AIRWORTHINESS DIRECTIVE GLIDERS/POWERED SAILPLANES

GFA/AD 239
GROB 21
Issue 1
12/8/1982
Sheet 1 of 2

Grob Twin Astir

Inspection and replacement of the front pilot's rudder pedal slide unit. Part No. 103-4208-10.

Picture 1:

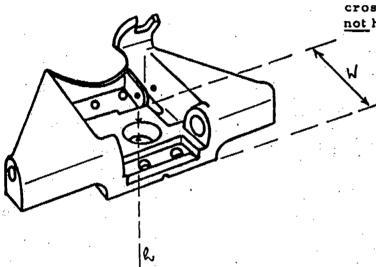
1. Before next flight Inspection of the slide at the front pedal unit before next start. If the slide no. 103B-4208.10 (picture 1) with the wide, high cross-web is installed, there is no reason for modification. Instructions 1 and 2 are not applicable.

If the slide No. 103-4208.10 (picture 2) with the small low cross-web is installed, actions 2 and 3 have to be carried out.

The slide No. 103-4208.10 (picture 2) has to be exchanged against slide No. 103B-4208.10 (picture 1) not later than October 31, 1982. The necessary material for this purpose (see below) has to be ordered from the manufacturer or Australian distributor.

This slide with wide, high cross-web is safe and does not have to be exchanged.
